SERVICE BULLETIN

NUMBER: 12-203-16R
DATE: 07/14/16
REVISED: 12/15/20

SUBJECT: Squeaking Sound from Front Seat Buckle

OLD Wave Washer

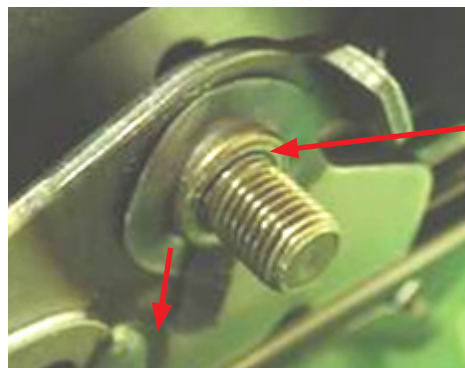
The 3 “tang” seen on the inside of the **OLD** wave washer have been deleted. The new washer also has a goldish-color flurocarbon resin coating. The inside diameter of the **NEW** spring wave washer has been decreased and a small felt added to allow the washer to turn smoother with the buckle and have a better fit on the shoulder portion of the retaining bolt.

**Shouldered
Portion**

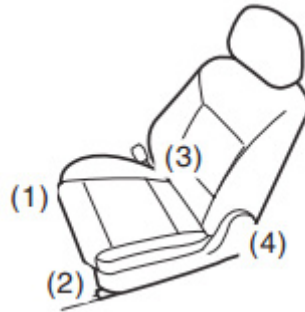
- Install the new spring wave washer onto the groove in the shouldered portion of the mounting bolt as shown below. The felt portion should be at about the 6:00 position (pointing down).
